SBM-23-2071

**Re: Response Letter for SPA2 Submission Comments  
Proposed Warehouse  
33 Park Road, Simcoe, ON**

This response letter has been prepared by Strik, Baldinelli, Moniz Ltd. (SBM) to address the requirements of the Site Plan Approval Comments, received and updated September 10, 2025, for the proposed development located at 33 Park Road in the County of Norfolk (County). This response letter shall be read in conjunction with the Site Plan and Engineering Documents prepared by SBM.

C1

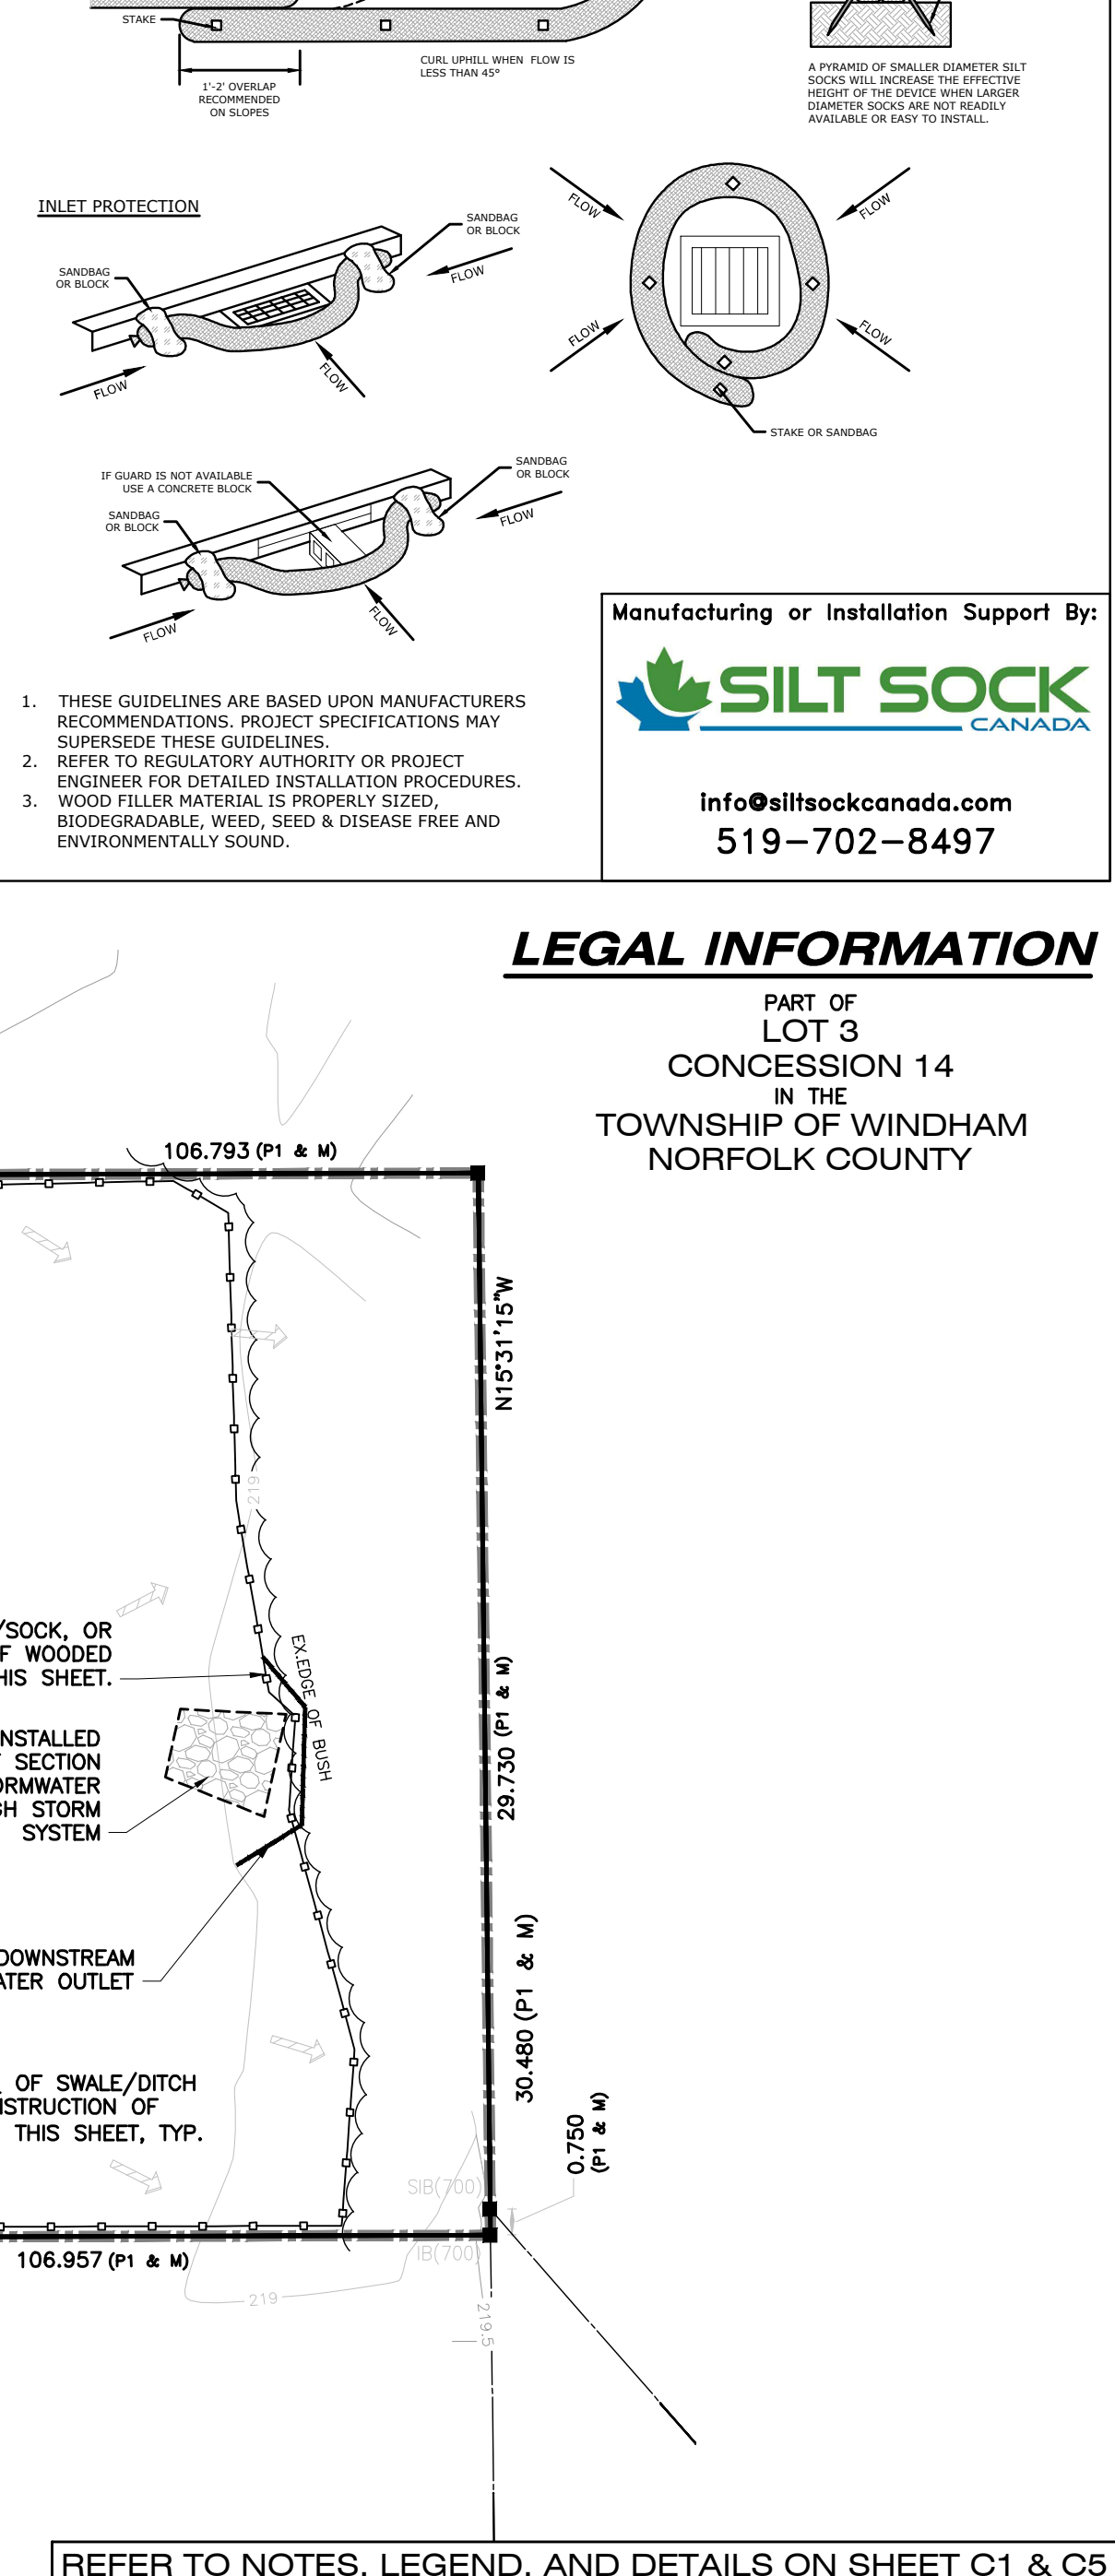
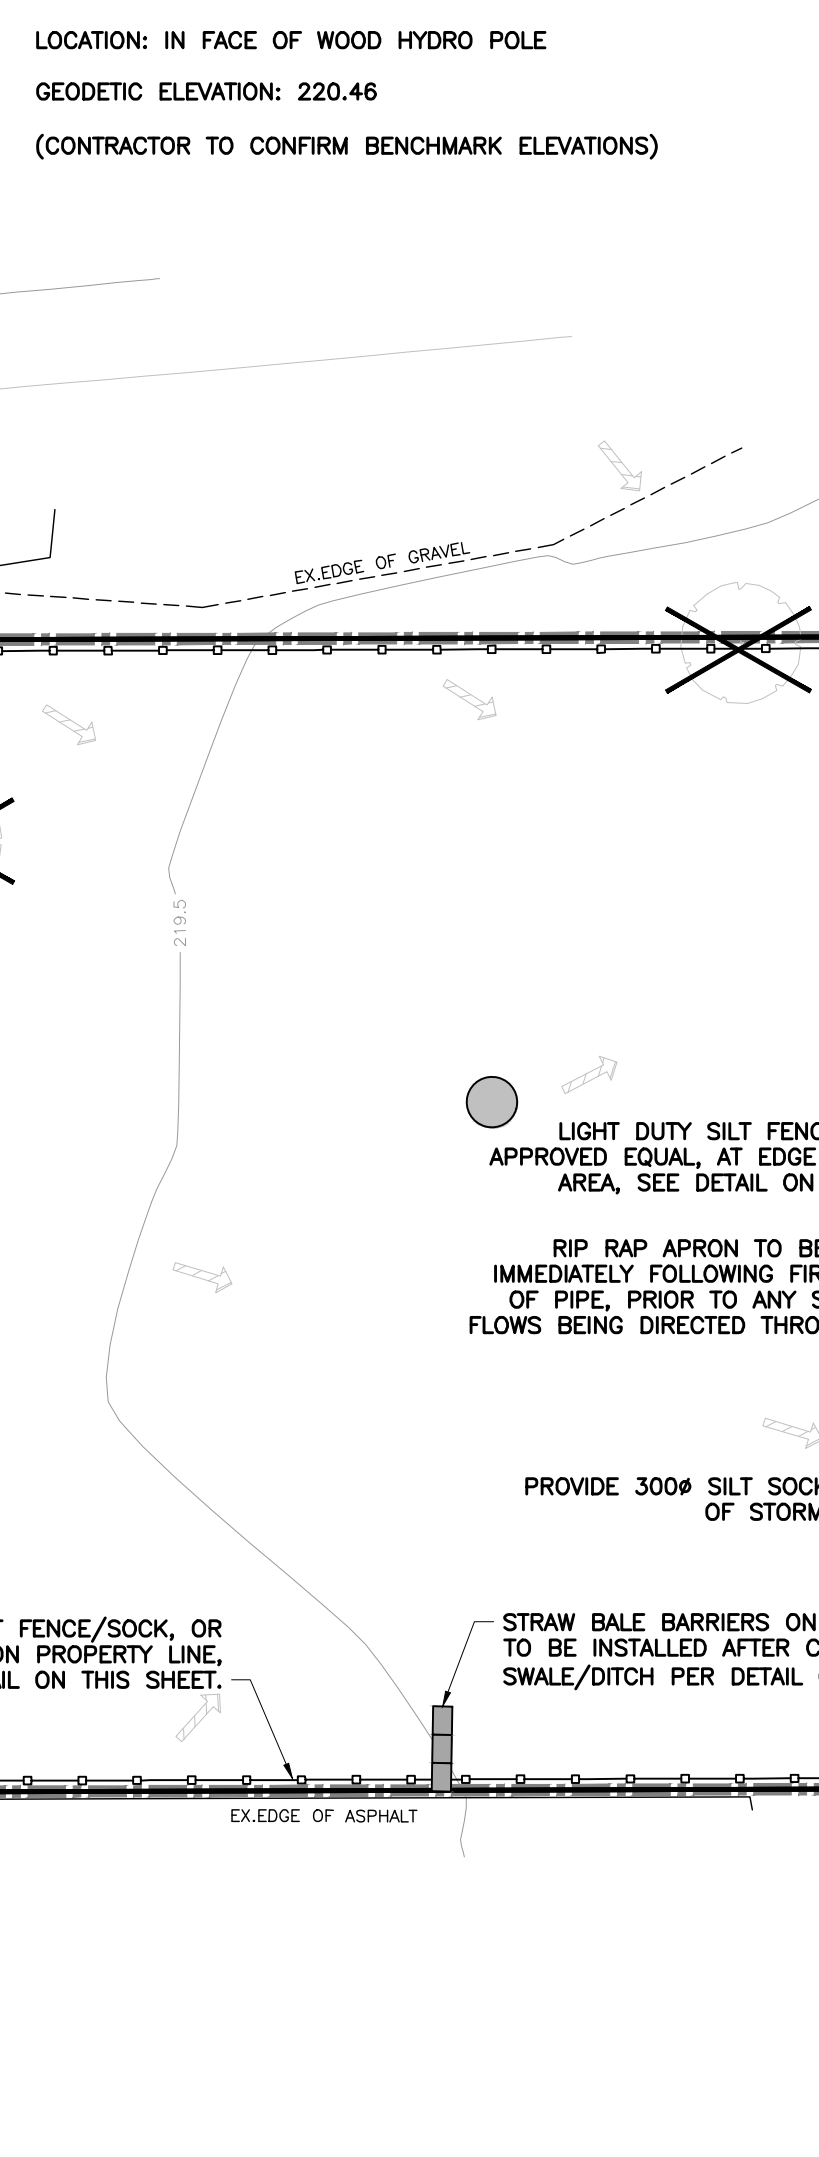
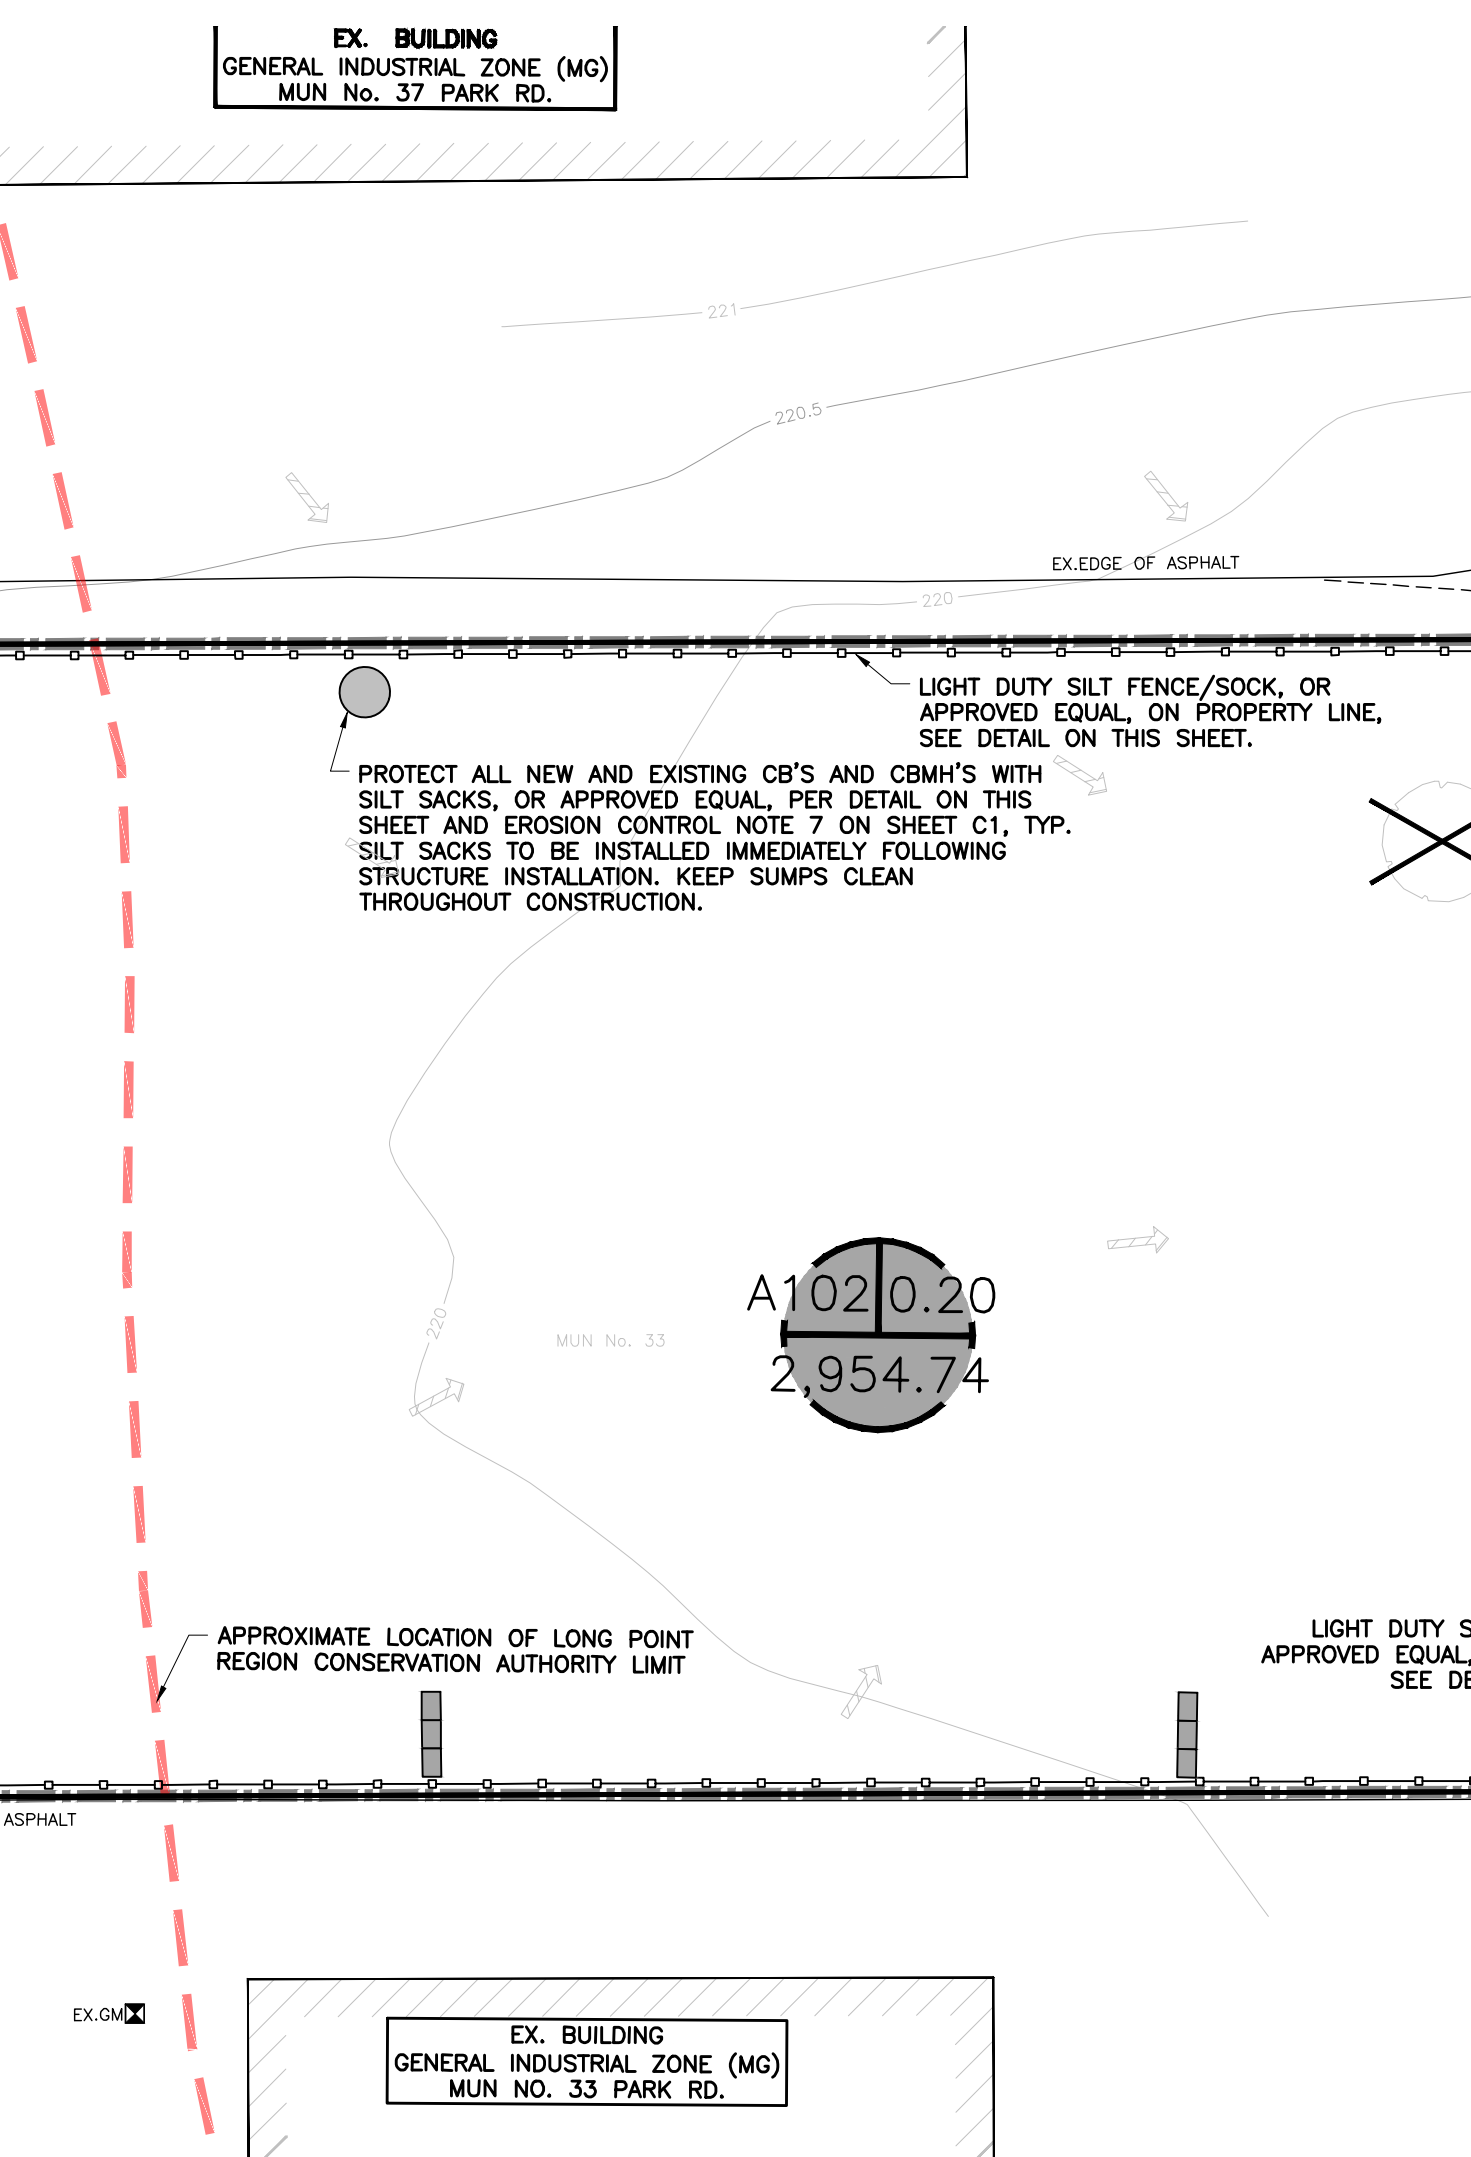
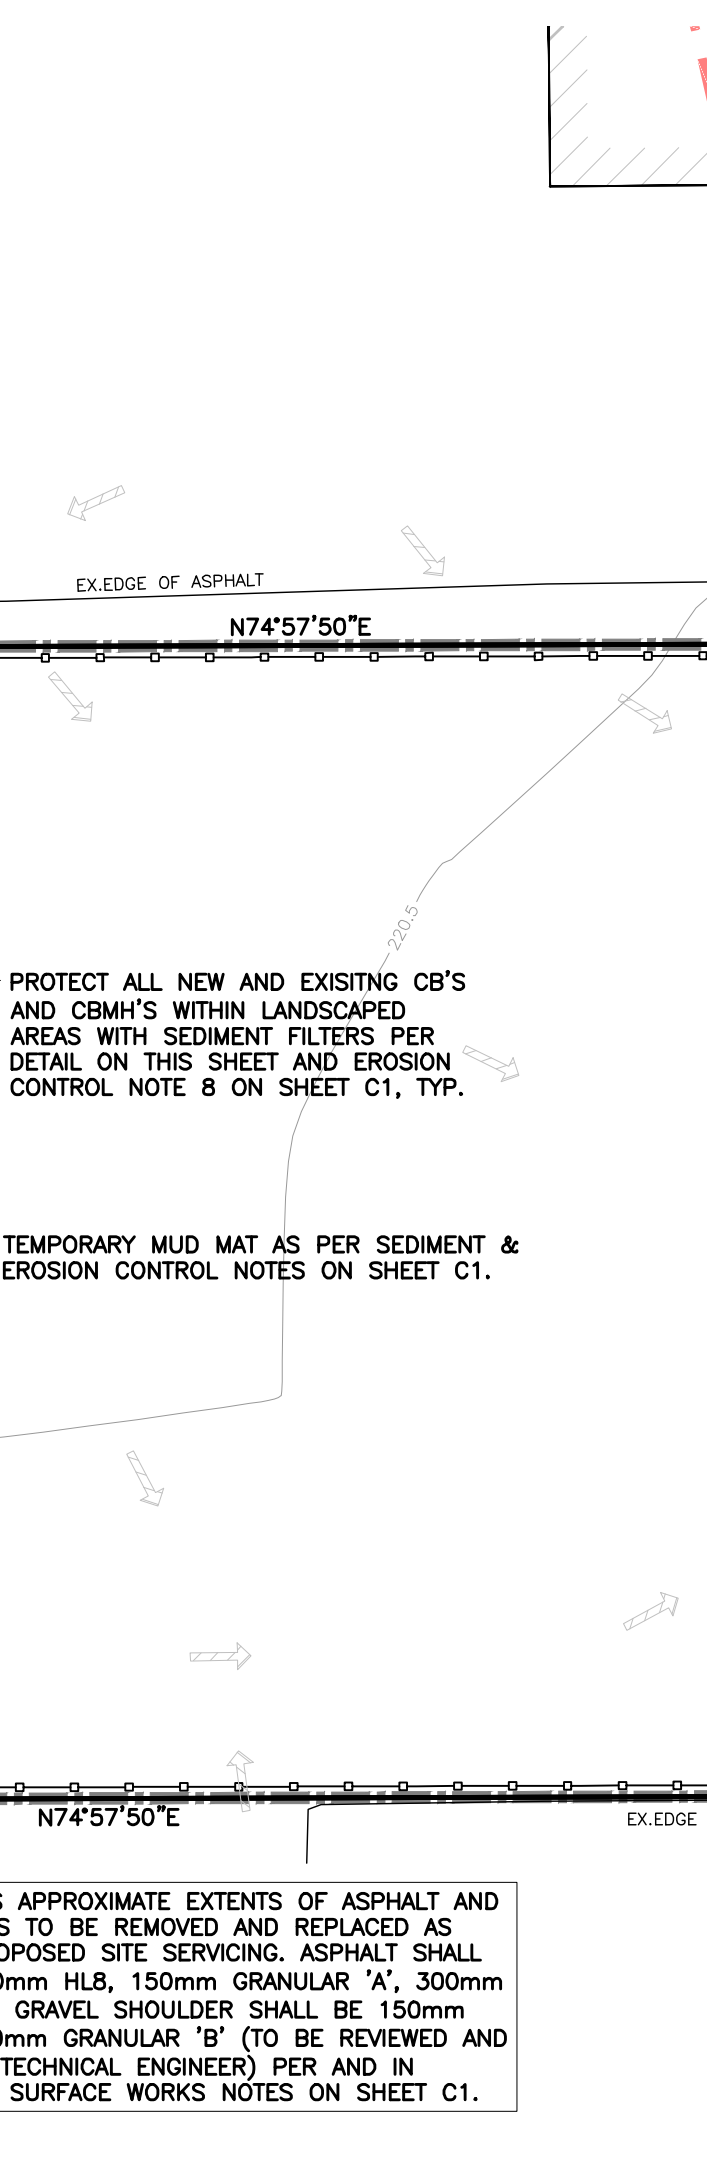
6. Following construction, an inspection of the outlet and riprap protection is recommended to confirm stability and effectiveness.

*Response by SBM: Acknowledged. Refer to notes on drawing and in the design brief which speak to post-construction ESC review. Specifically, ESC Note 20 on sheet C1 as well as an additional site review item in the "List of items requiring engineer's review" table on sheet C1.*
